## **REMARKS**

Amendments to the Drawings

ANNOTATED SHEET 2 SHOWING CHANGES

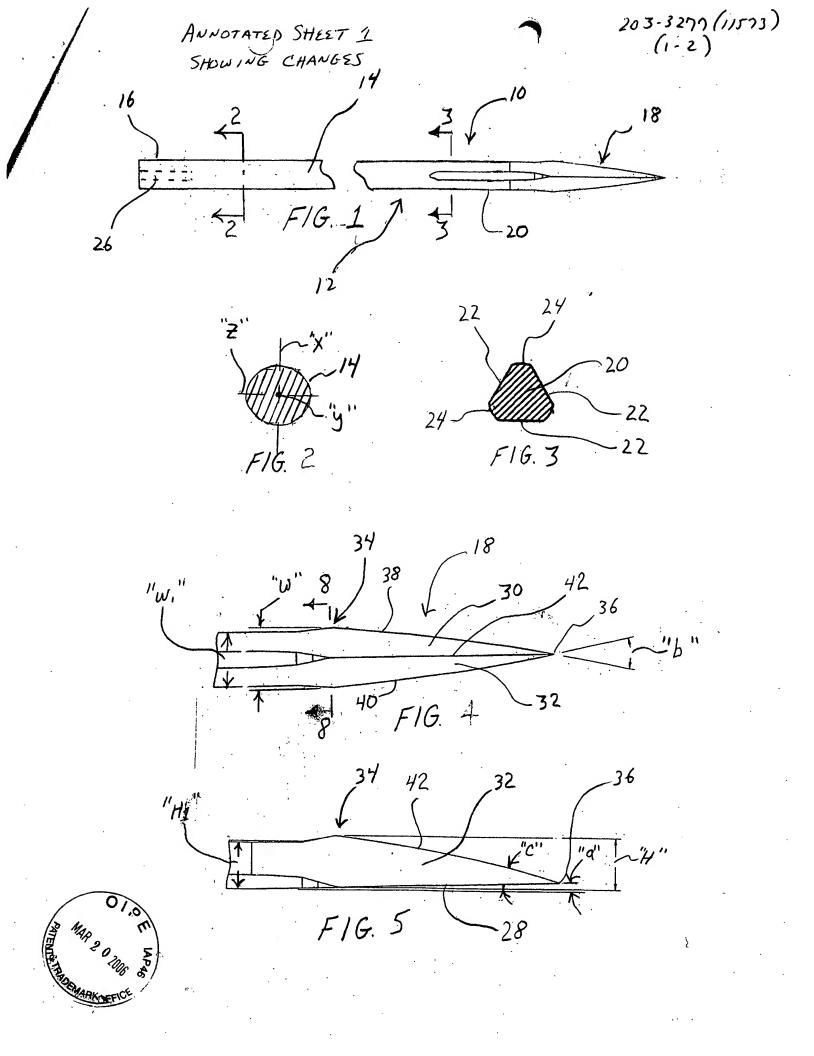
The attached new replacement sheets 1 and 2 of the drawings includes changes to

respectively, replace the original sheets. In FIG. 1, the elongated body 12 is identified. In FIG.

9, the bisecting median plane "m" is identified.
